ADDENDUM NO. 2

March 1, 2022

**TIMOTHY BALL ELEMENTARY SCHOOL ADDITIONS, RENOVATIONS,
AND RELATED WORK
Crown Point, IN 46307**

This Addendum forms a part of and modifies the Bidding Requirements, Contract Forms, Contract Conditions, the Specifications, and the Drawings dated February 7, 2022 by Gibraltar Design. Acknowledge receipt of the Addendum in the space provided on the Bid Form. Failure to do so may subject the Bidder to disqualification.

Thursday, 2/24/2022 - 1:10 PM - LAST SAVED BY: JAMESLEY
Y:\21-112 CROWN POINT CSC - TIMOTHY BALL ES
ADDITION AND RENOVATIONS\21-112 DRAWINGS\05
ARCH\A-416.DWG

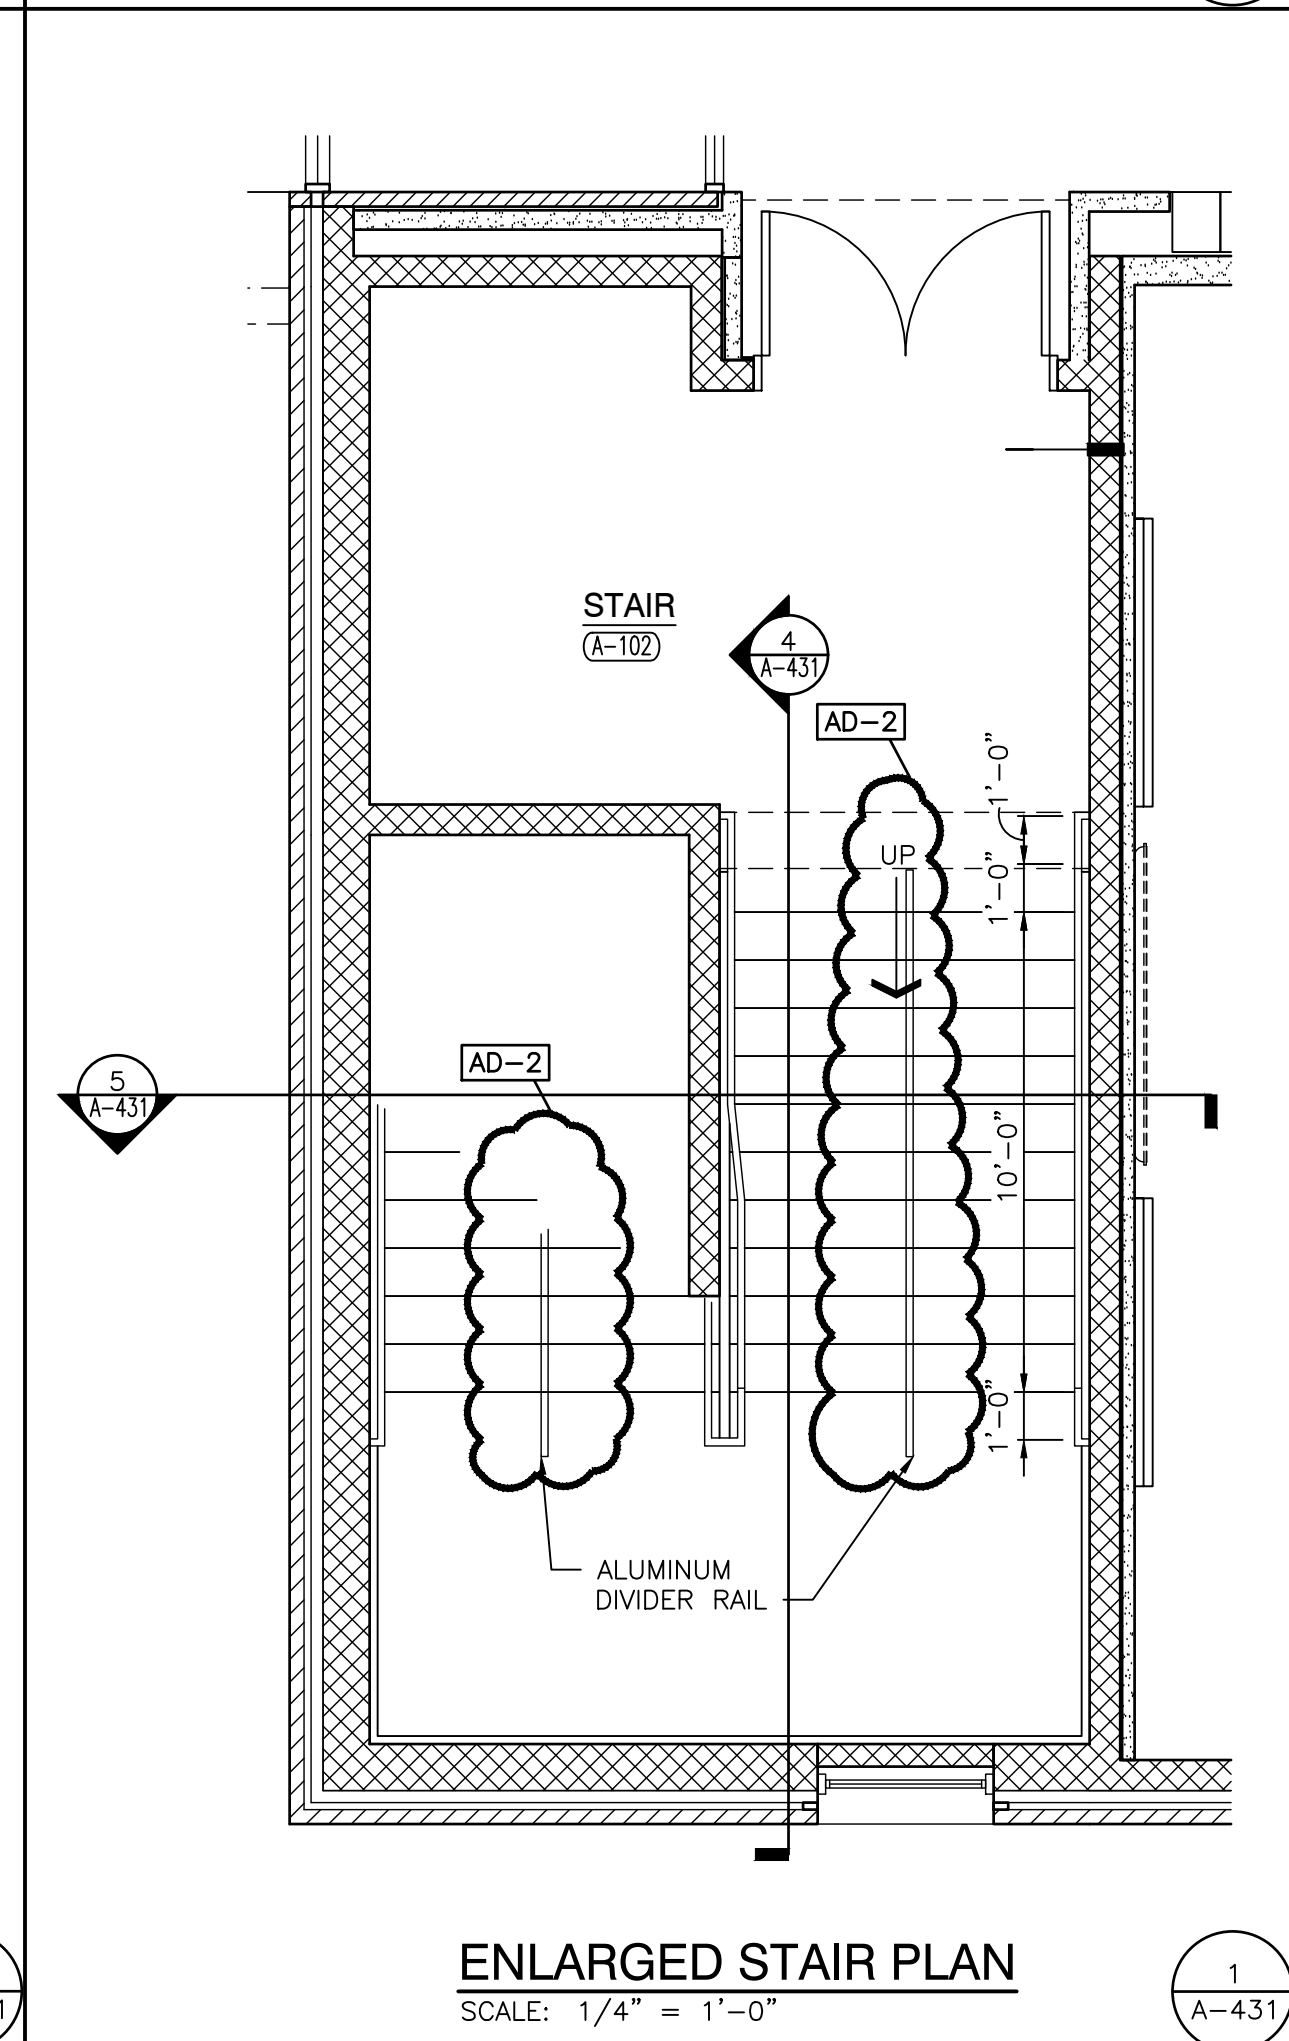
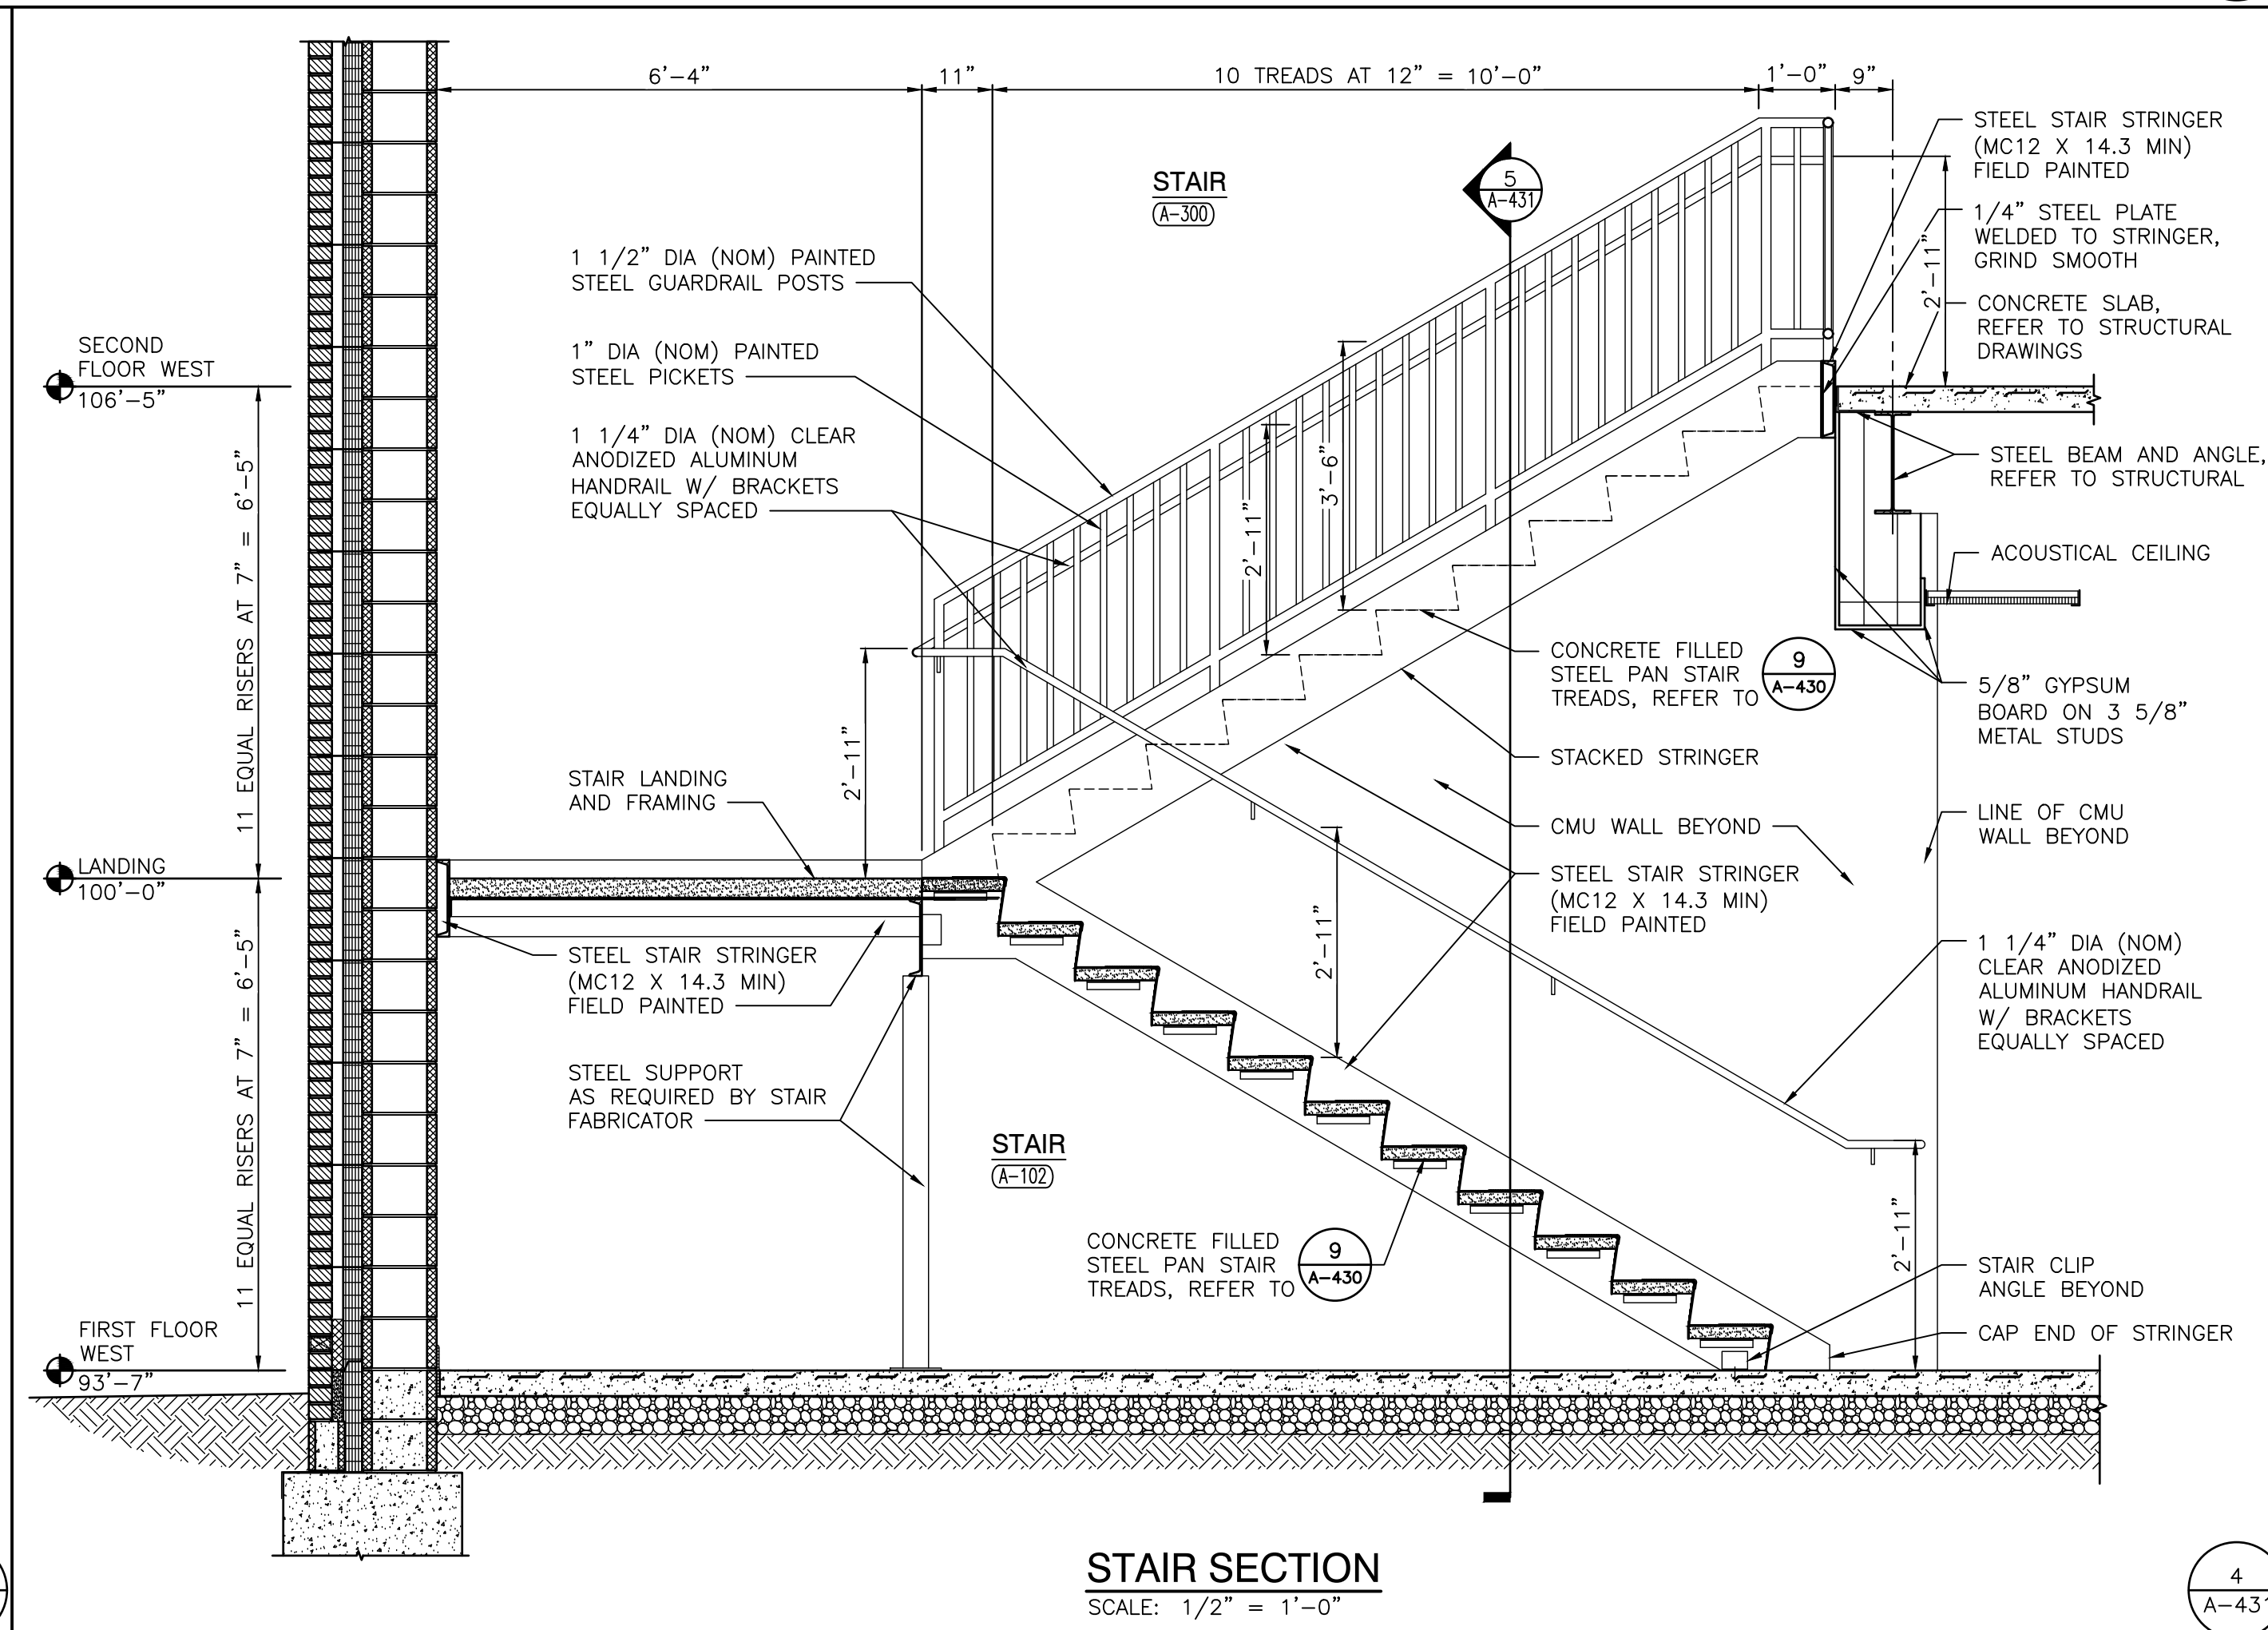
13. Sheet A-416

1. Revise Wall Section 3/A-416.
2. Refer to Section Drawing for clouded dimension revisions in multiple locations.
